REVISIONS

PROJECT REFERENCE NO.	SHEET NO.
R-3825B	21
R/W SHEET NO.

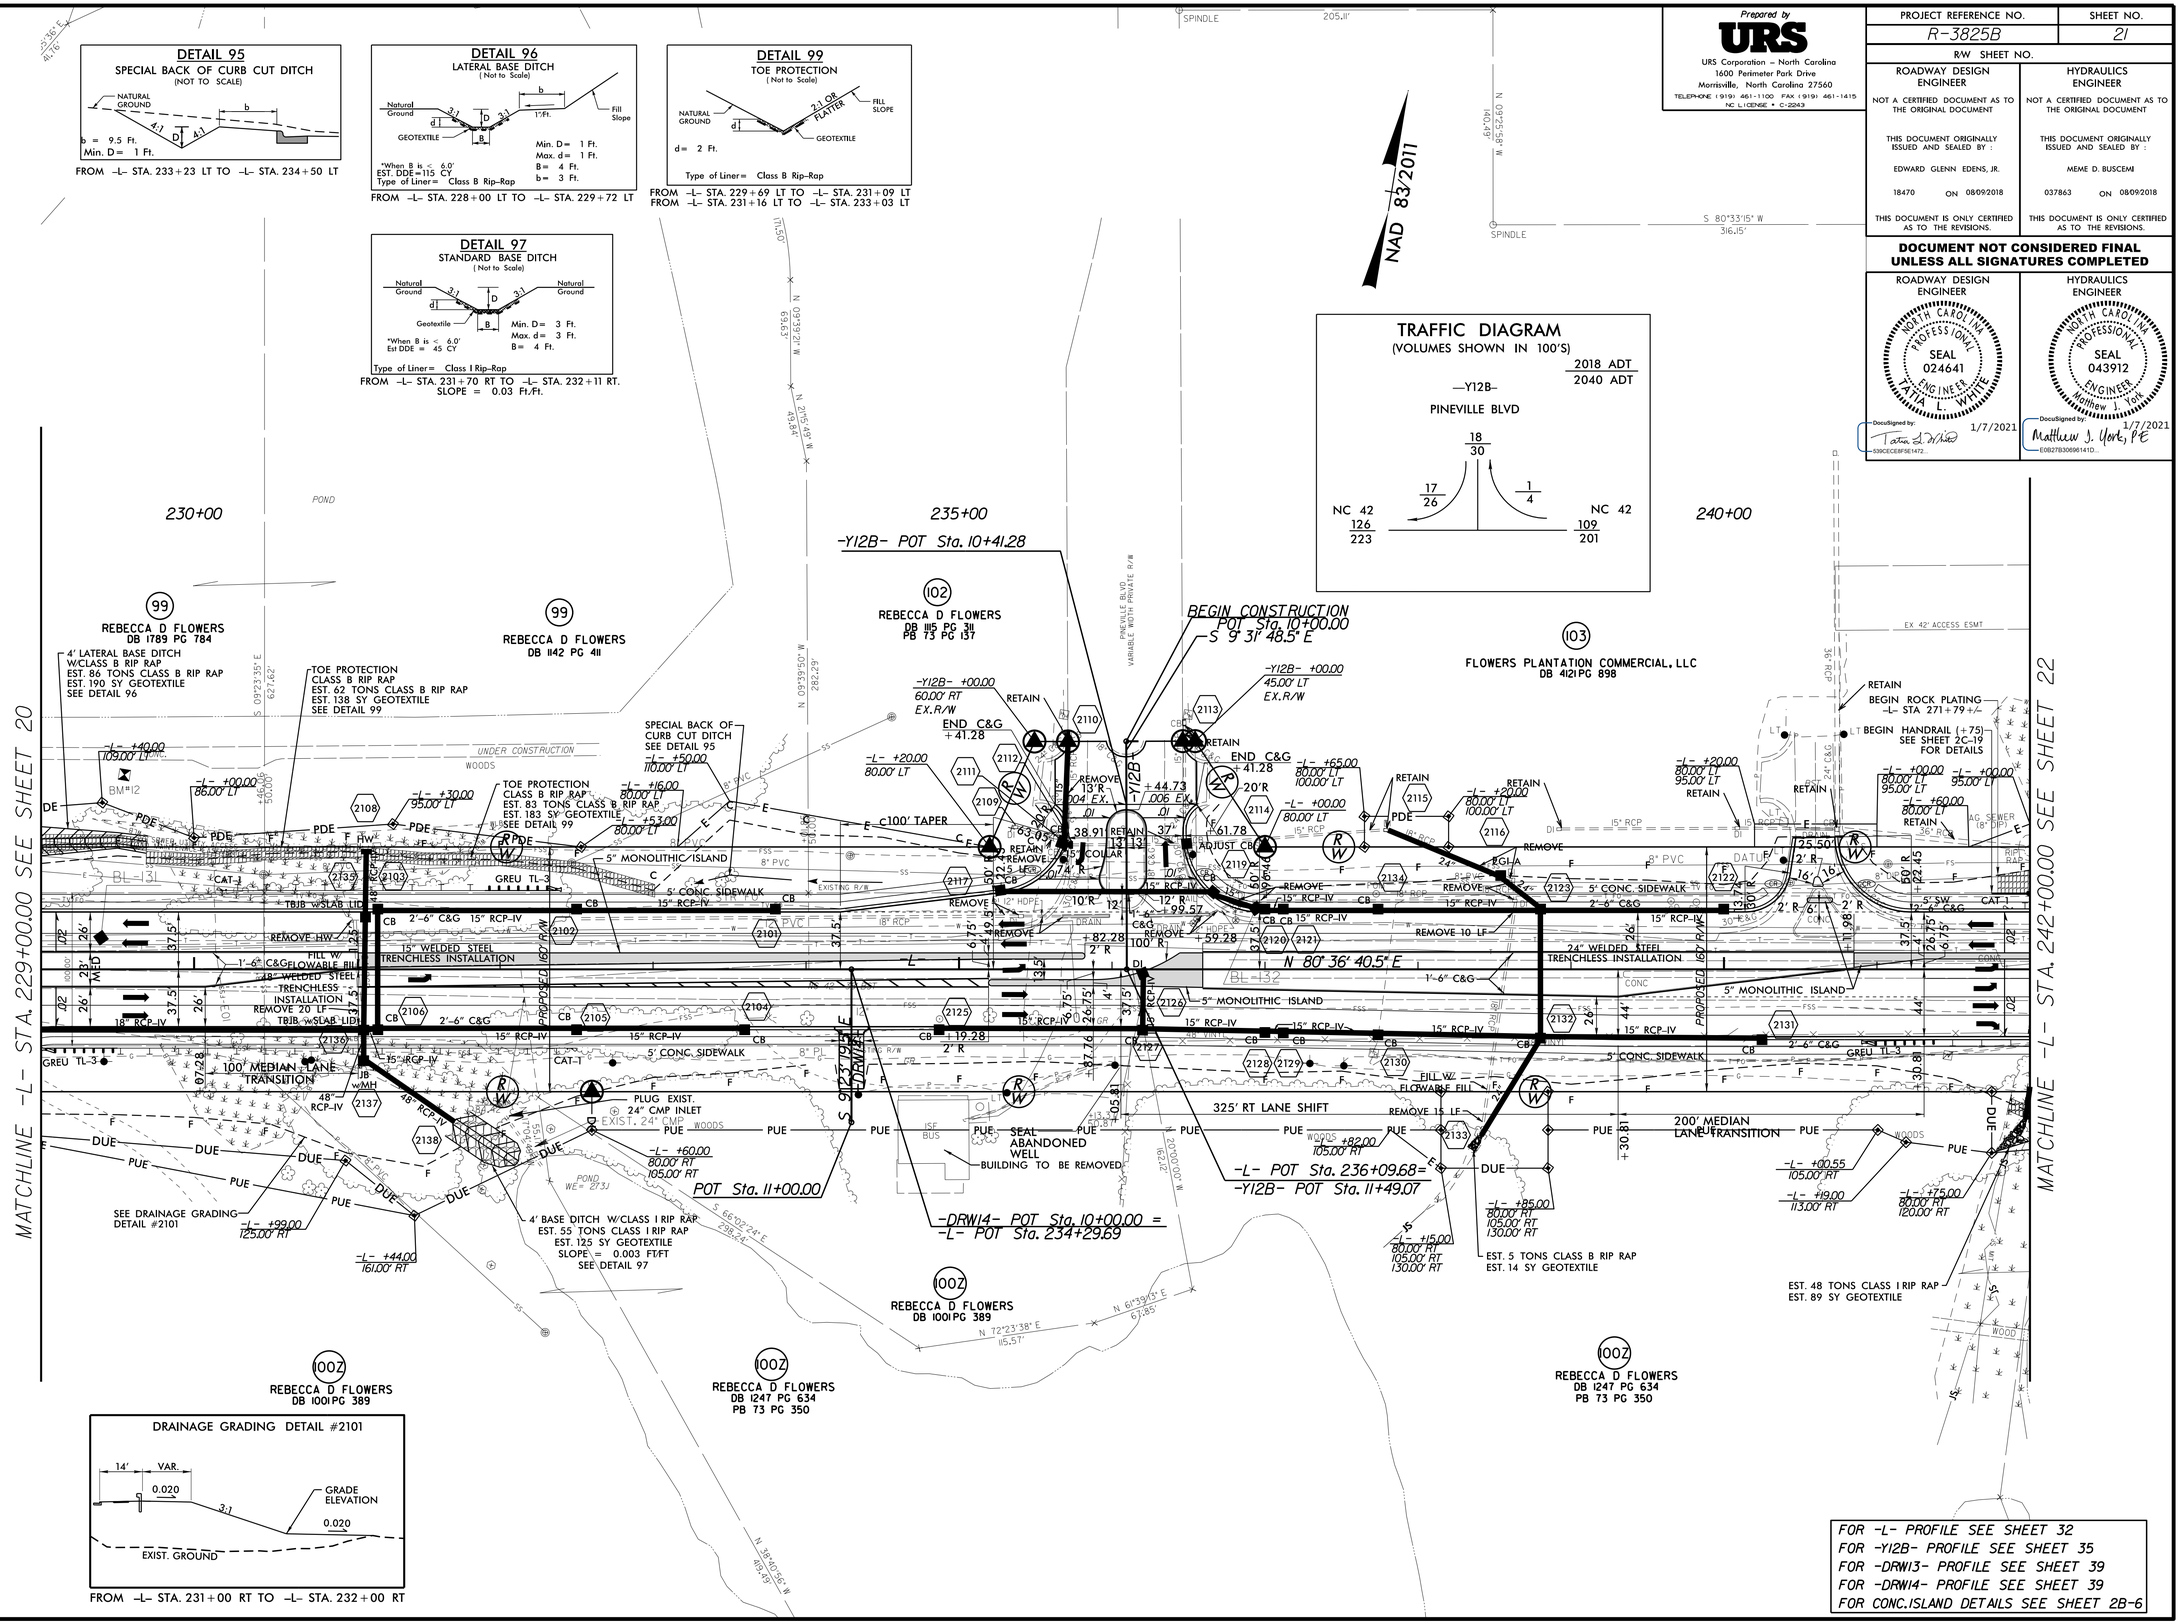
1 – ROW, PUE, PDE, AND EASEMENTS UPDATED ON PARCEL 100 FROM STA. 218+77 TO 244+77 (10/12/2018) TLH
10/16/2019 – CONSTRUCTION REVISION: REMOVED –DRW13– AT –L– STA. 228+86.87 TO 229+52.33 RIGHT. HYDRAULICS PIPE AND DITCH WAS REVISED FOR –DRW13– REMOVAL. HN
08/17/2020 – CONSTRUCTION REVISION: REVISED THE BERM WIDTH, SLOPES AND DRAINAGE TO TIE TO THE DEVELOPER'S SITE PLAN FROM –L– STA. 229+00 TO 233+00; AND ADDED A DRAINAGE GRADING DETAIL #2101. HN
01/08/2021 – CONSTRUCTION REVISION: ADJUSTED GUARDRAIL. WIDENED BERM AND ADDED HANDRAIL. STEEPENED SLOPE AND ADDED ROCK PLATING. –L– STA. 241+75 TO 242+00 LT. (HN)
